Struthers Ranch Polaris Grading & Erosion Control Plans El Paso County, Colorado

C1.0	GEC PLAN TITLE SHEET
G2	GENERAL NOTES & LEGEND
C1.1	SITE GRADING & EROSION CONTROL PLAN
C3.1	DETENTION POND PLAN & DETAILS
C4.1	CIVIL & EROSION CONTROL DETAILS
C4.2	EROSION CONTROL NOTES & DETAILS

**SITE GRADING AND
 EROSION CONTROL PLAN**

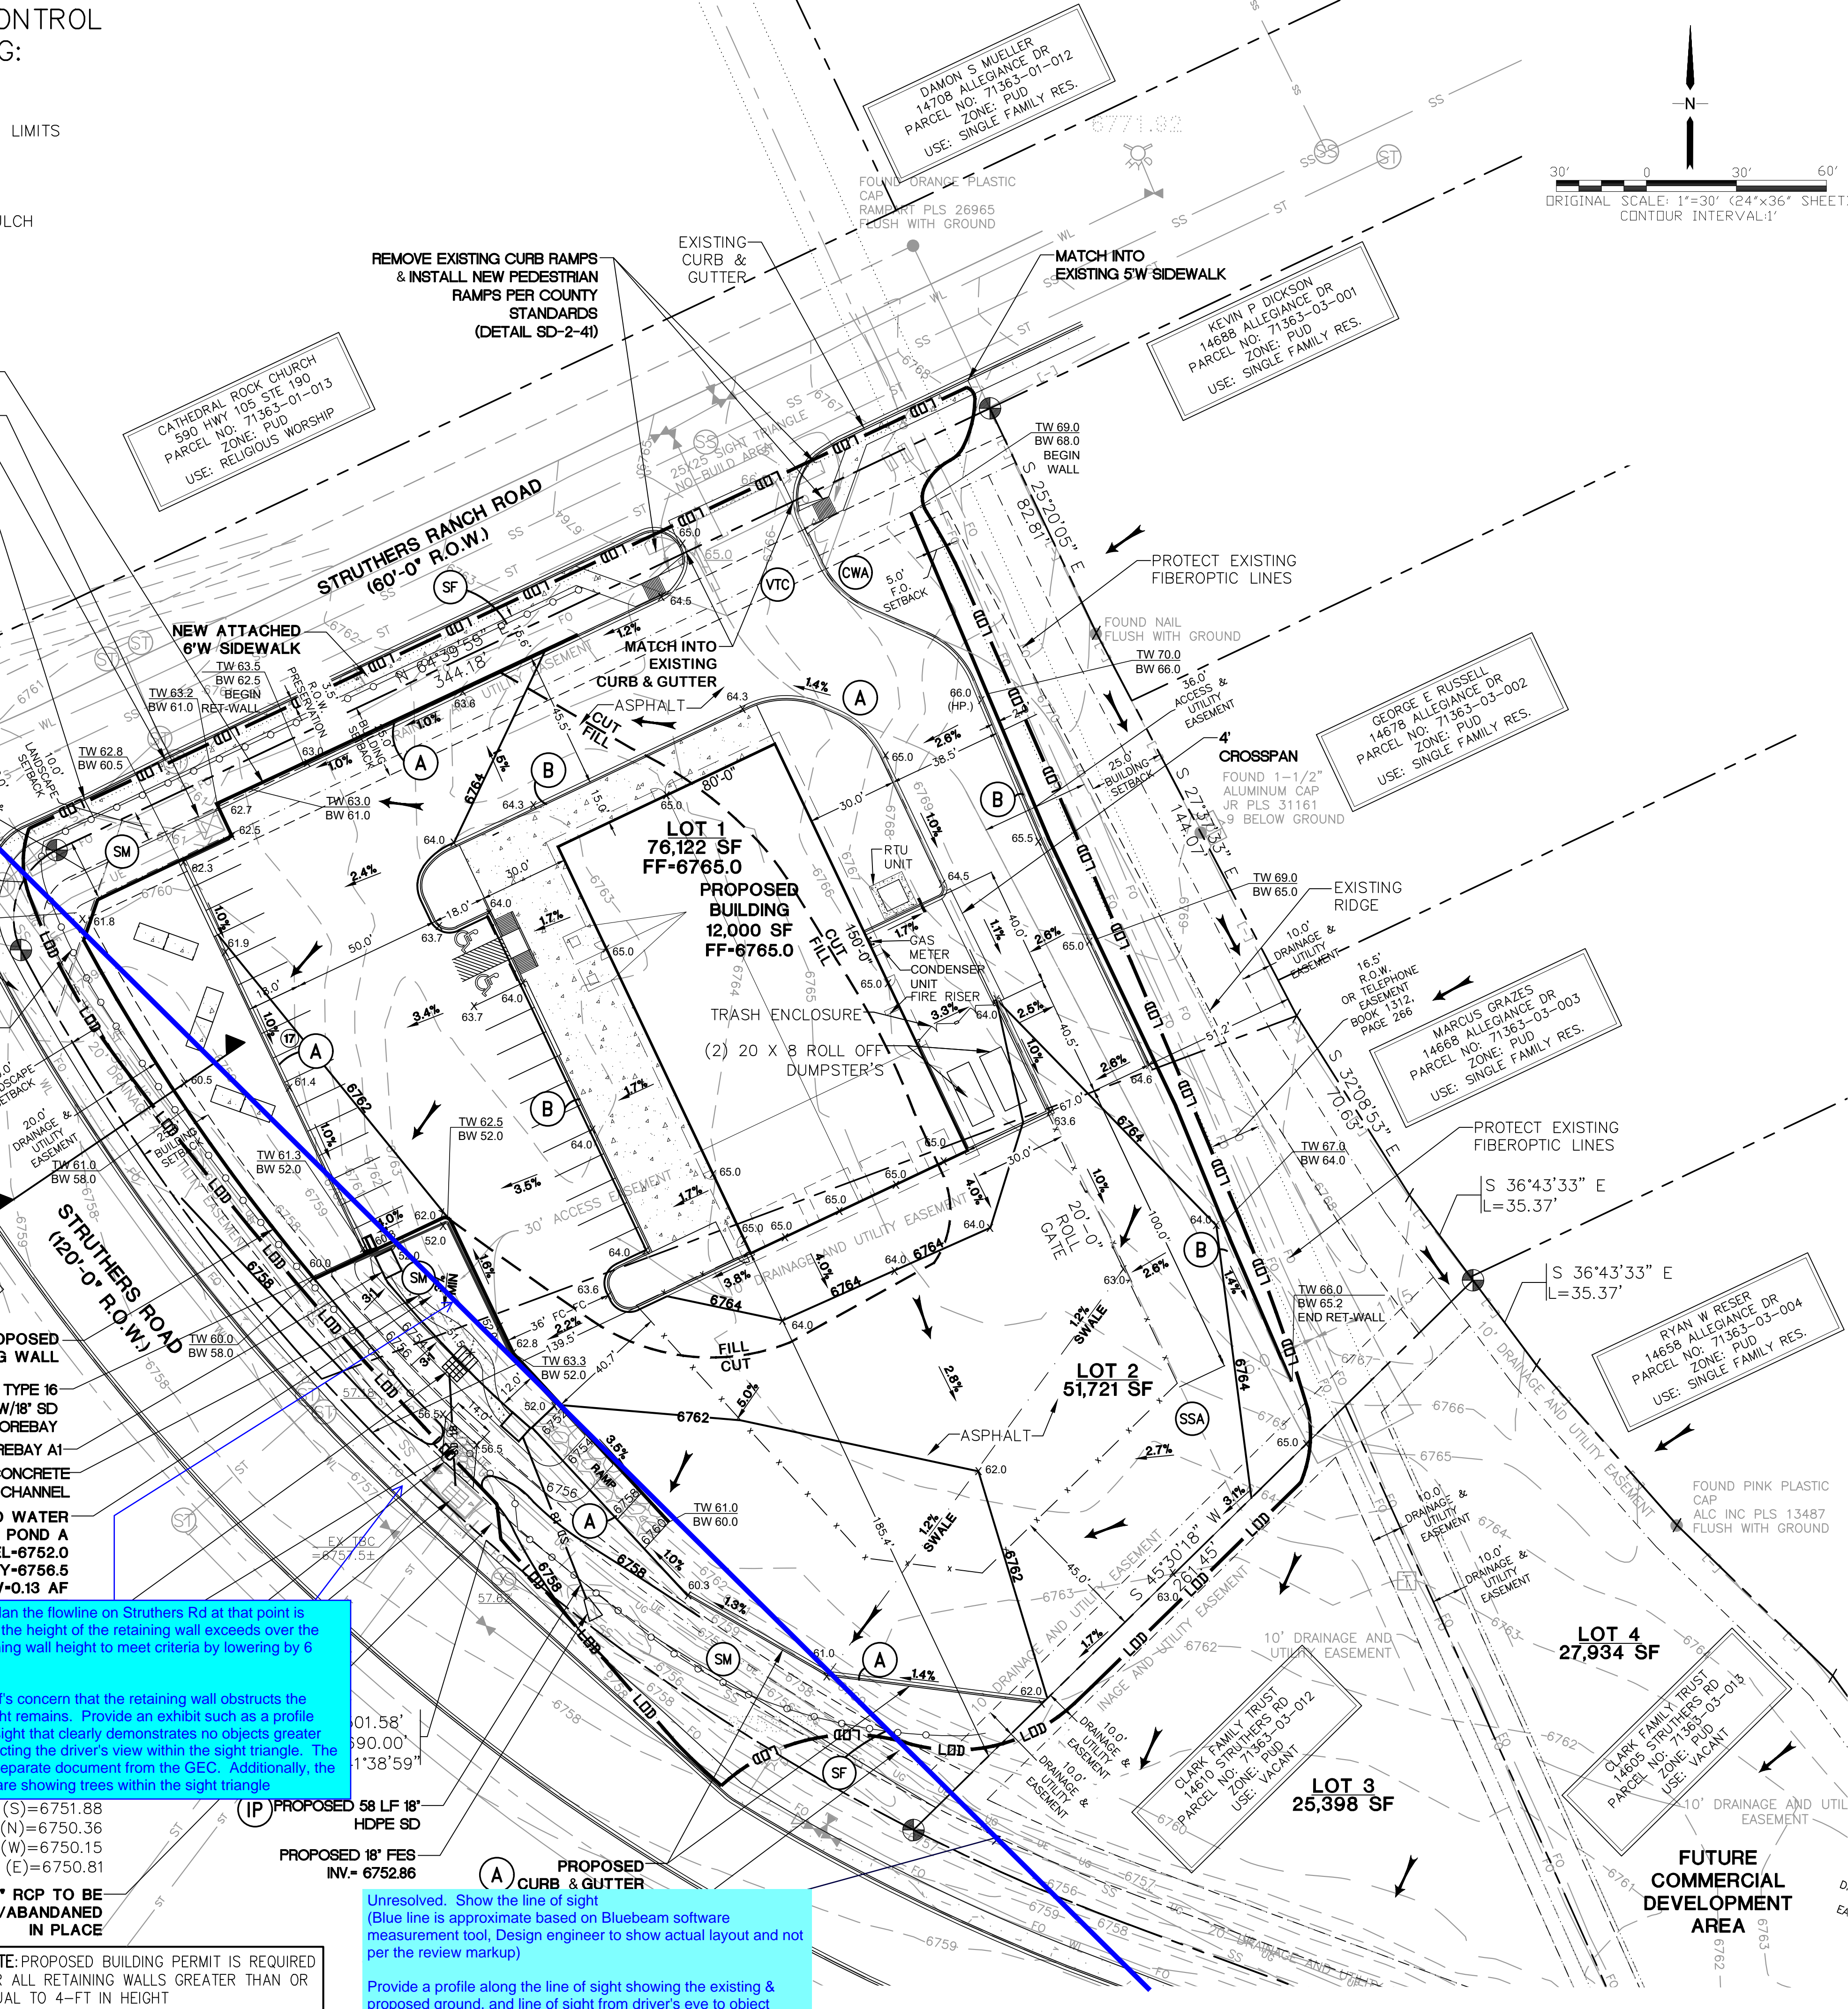
Unresolved. Show the line of sight (Blue line is approximate based on Bluebeam software measurement tool, Design engineer to show actual layout and not per the review markup)

Provide a profile along the line of sight showing the existing & proposed ground, and line of sight from driver's eye to object height per criteria.
